# PARTS & SERVICE NEWS

REF NO.	AT03188
DATE	Sep. 24, 2003
(C) Page 1 of 4

**SUBJECT:** REPLACEMENT OF STEERING VALVE MOUNTING BRACKET ON WA320-5

**APPLICATION:** WA320-5 Wheel Loaders, Serial Nos. 60004 thru 60038

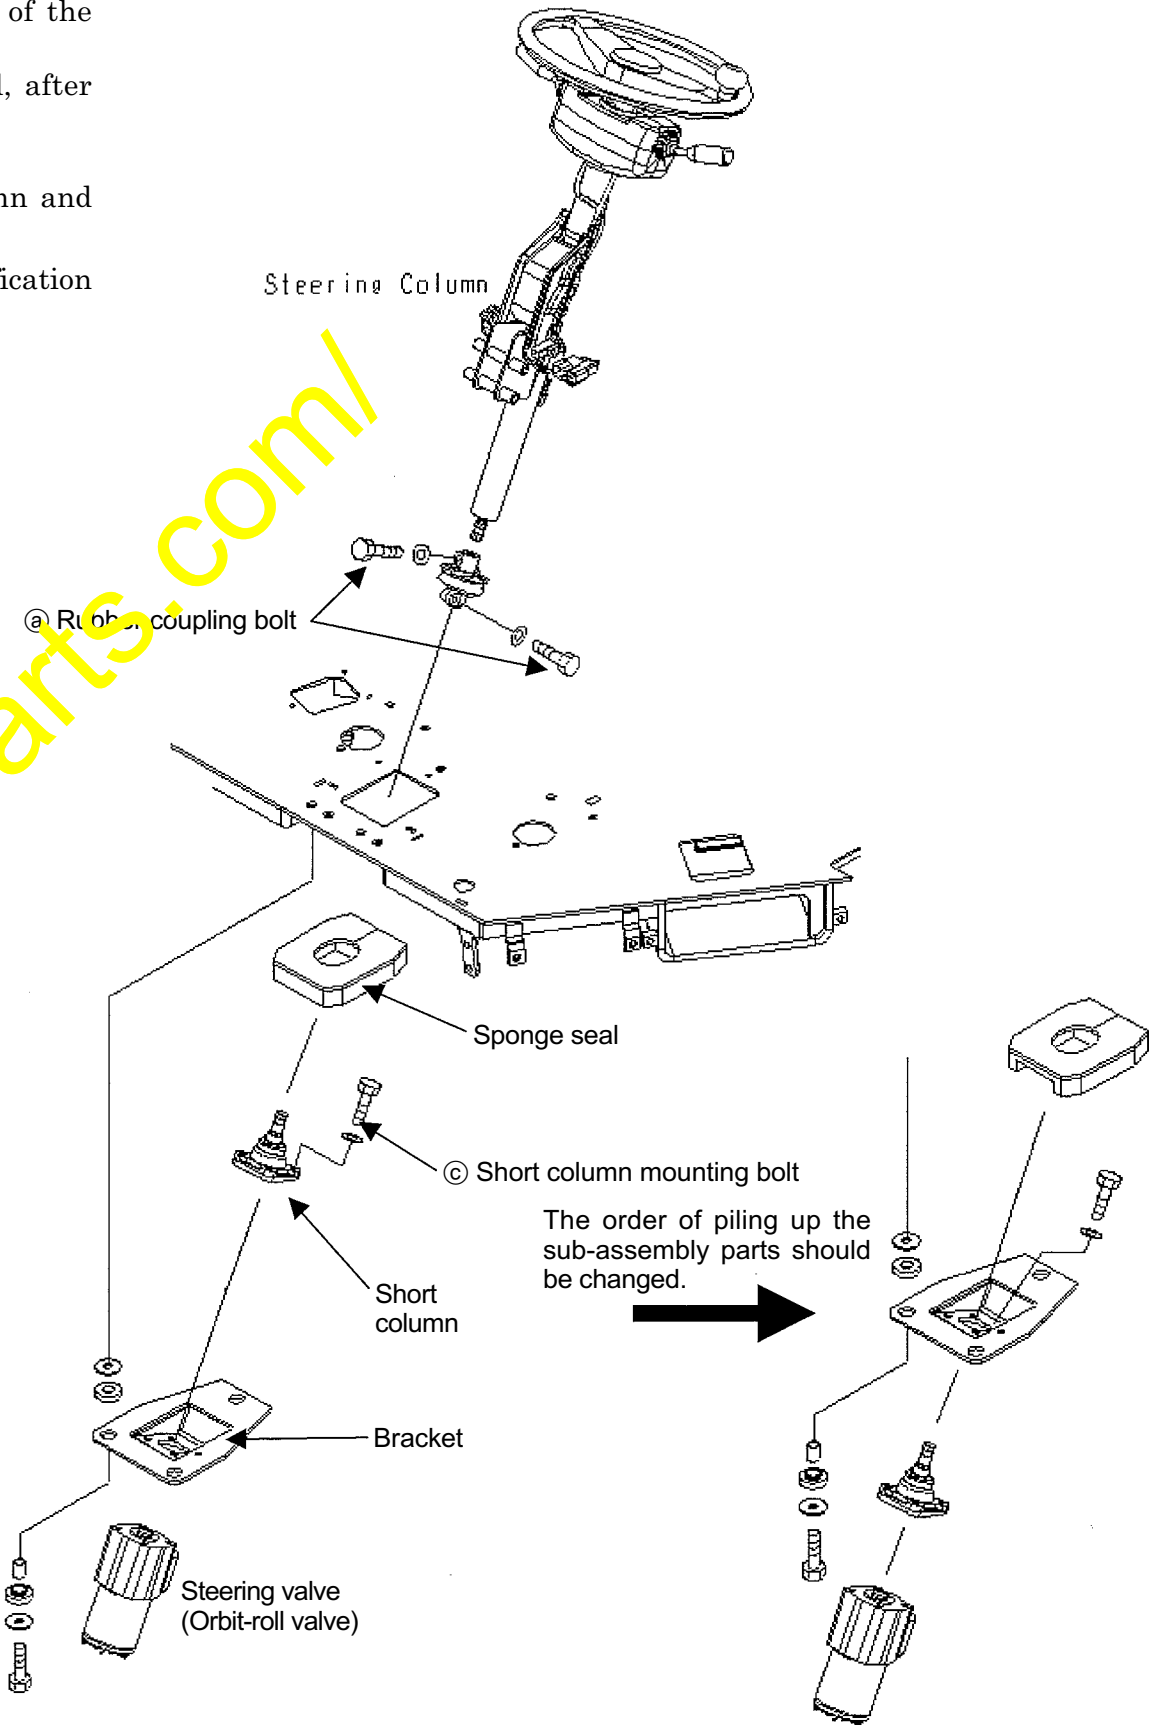
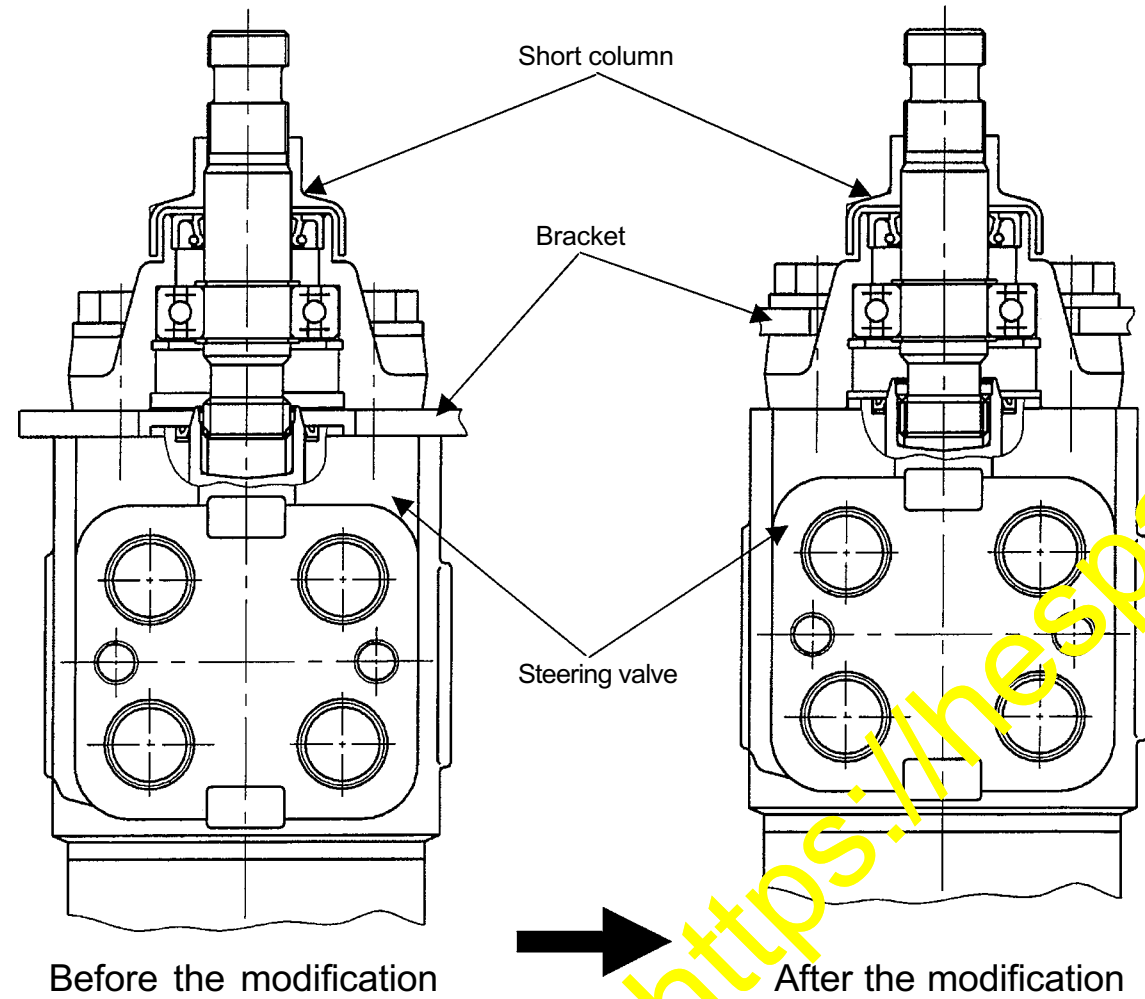
Since the spline engagement depth between the steering valve being positioned under the floor and the steering column shaft is insufficient, in case an operating effort of 10 kg or more is applied at the steering end, there is a possibility of occurrence of increase in the backlash because of spline wears.

The shape of the steering valve mounting bracket has been changed to change the valve mounting structure.  
(Refer to the drawing indicated on the RH side.)

- (1) After removing the column cover being positioned in the inside of the operator's cab, remove 2 pieces of the rubber coupling bolt ①.
  - Then, remove 3 pieces of steering valve bracket mounting bolt ② being positioned under the floor and, after that, remove the sub-assembly of the short column, bracket, and valve.
  - (2) Remove the short column mounting bolt ③ and remove the bracket.
  - (3) Replace the removed bracket to the improved bracket and pile up in the order of the valve, short column and the bracket, from down to upward, to assemble the sub-assembly. (Refer to the drawing indicated below.)
- ▲ Be careful since the order of piling up the sub-assembly is different between the status before the modification and the status after the modification.

- (4) Replacing the sponge seal to the improved seal, install the bracket from under the floor. In the meantime, the current sponge seal may also be used after reworking. Refer to page 4 regarding the reworking procedure.

- (5) To adjust the steering wheel operating effort, loosen the mounting bolt ④ of the lock plate for the lower section of the steering column and tighten the rubber coupling bolt and lock plate mounting bolt so that the shaft center of the steering column and the shaft center of the short column may match.

After finishing the above adjustment, start the engine and turn the steering wheel to confirm that the operating effort is equal and, at the same time, the steering effort is 1.5 kg or less. (Engine Lo-Idling speed)
